# Access Compliance Report

## Public Rights-of-Way

Intersection ID: 21122	Main Street: SHARON_VIEW_RD	Cross Street: WINDING_BROOK_RD	Location: SE
ADA ID: 6D4F546B069F	Ramp Type: PerpDiag	Initial Pass/Fail: Fail	Overall Compliance: No
		Severity Score: 25

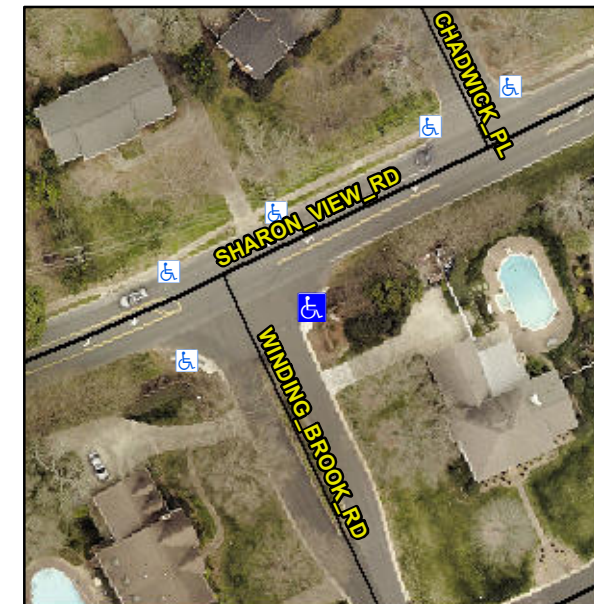
**Not Found, R304.2.2**

Compliance	Description	Data	Compliance	Description	Data
N/A	Ramp Length (in)	49.0	No	Ramp Slope (%)	13.6
Yes	Ramp Width (in)	48.0	Yes	Ramp XSlope (%)	0.4
N/A	Flare Type LT	N/A	N/A	Flare Type RT	N/A
N/A	Flare Slope LT (%)	N/A	N/A	Flare Slope RT (%)	N/A
N/A	Flare Traversable LT?	N/A	N/A	Flare Traversable RT?	N/A
N/A	Landing Length (in)	N/A	N/A	DWS Provided?	N/A
N/A	Landing Width (in)	N/A	N/A	DWS Contrast?	N/A
N/A	Landing Slope (%)	N/A	N/A	DWS Length (in)	N/A
N/A	Landing X Slope (%)	N/A	N/A	DWS Full Width?	N/A
N/A	Landing Curb? (Y/N)	N/A	N/A	DWS Offset (in)	N/A
N/A	Shared Landing?	N/A			
N/A	Gutter Ponding?	N/A	N/A	Gutter Slope (%)	N/A
N/A	Gutter Lip Ht (in)	N/A	N/A	Gutter X Slope (%)	N/A
N/A	Painted X Walk1?	No	N/A	Painted X Walk2?	No
	X Walk 1 Direction	To N		X Walk 2 Direction	To W
N/A	X Walk 1 Width (in)	N/A	N/A	X Walk 2 Width (in)	N/A
	X Walk 1 Slope (%)	1.9		X Walk 2 Slope (%)	2.3
	X Walk 1 X Slope (%)	2.2		X Walk 2 X Slope (%)	0.9

**Remove & Replace Curb Ramp With Two New Directional Ramps or Equivalent.**
